PRELIMINARY DRAINAGE PLAN

LORSON RANCH EAST

JUNE 30, 2017

PUD SP-16-003

EXISTING CONDITIONS
LORSON RANCH EAST
EAST OF ETRIB OF JIMMY CAMP CREEK

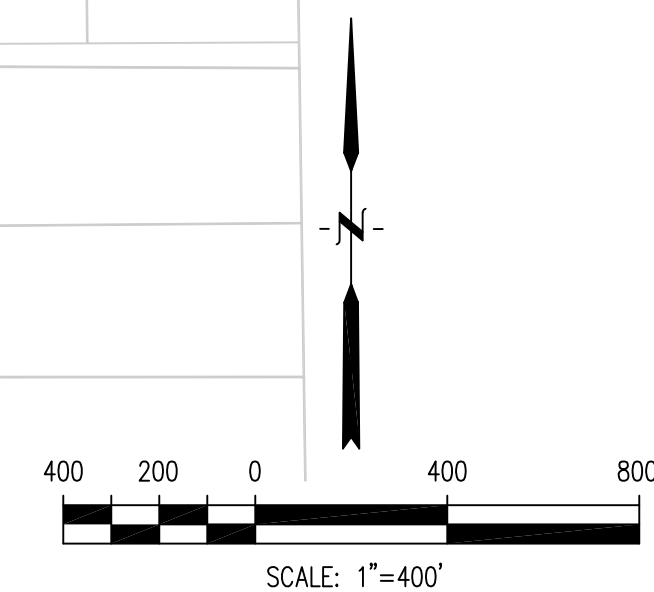
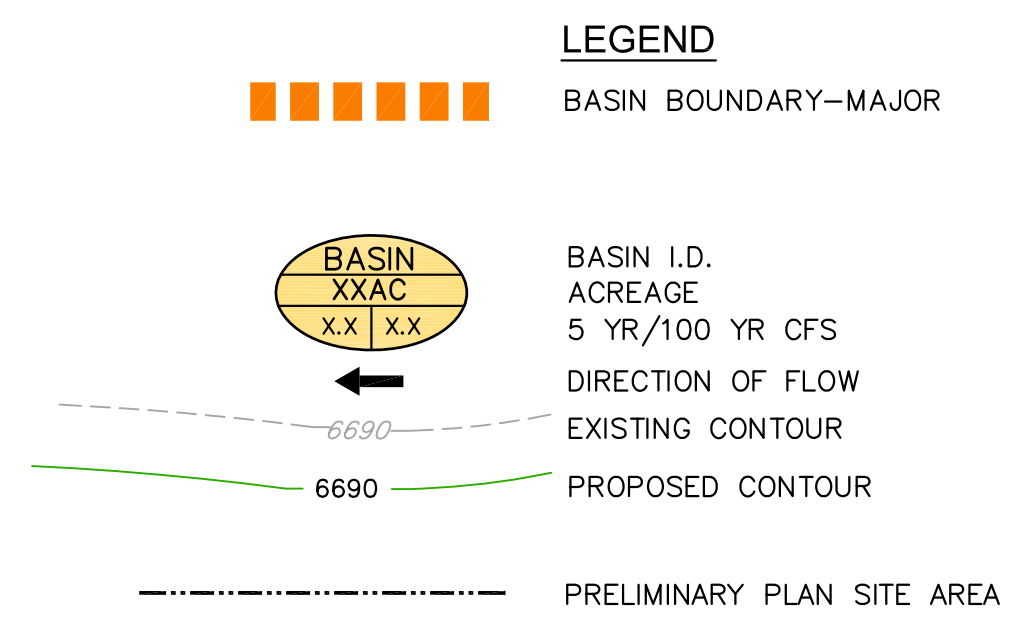
Provide DP for channel flow comparison

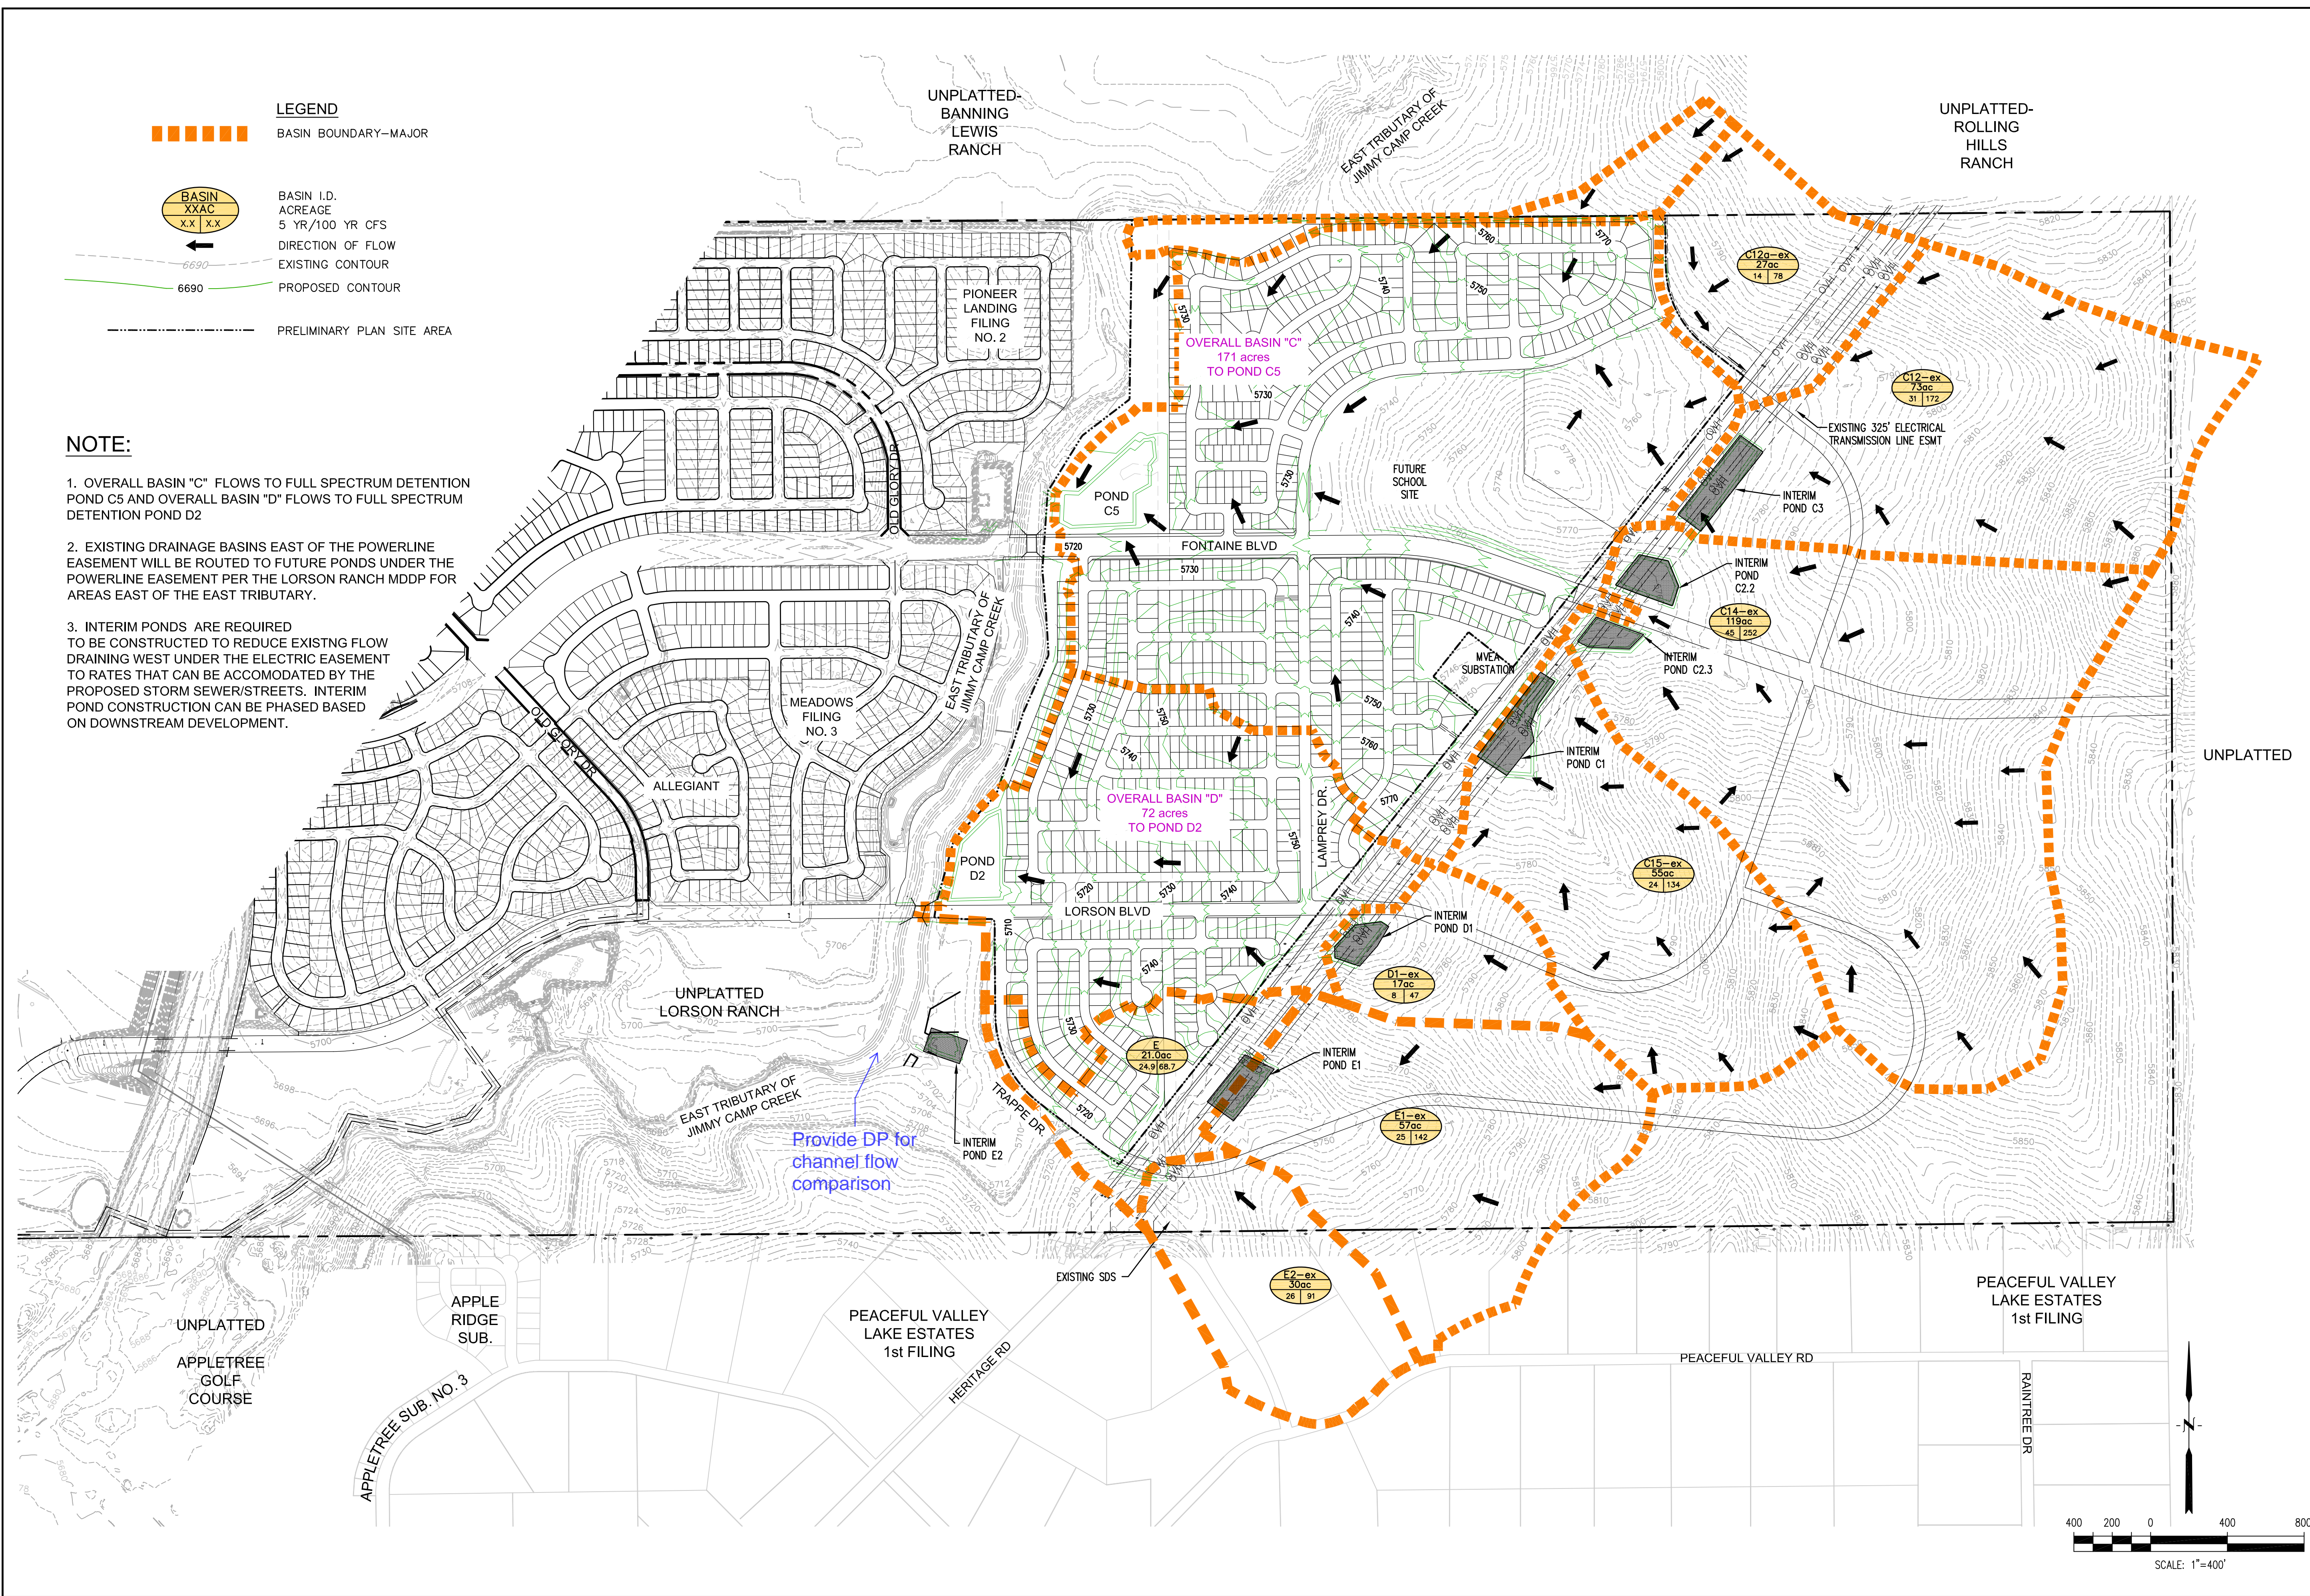
Provide DP for channel flow comparison
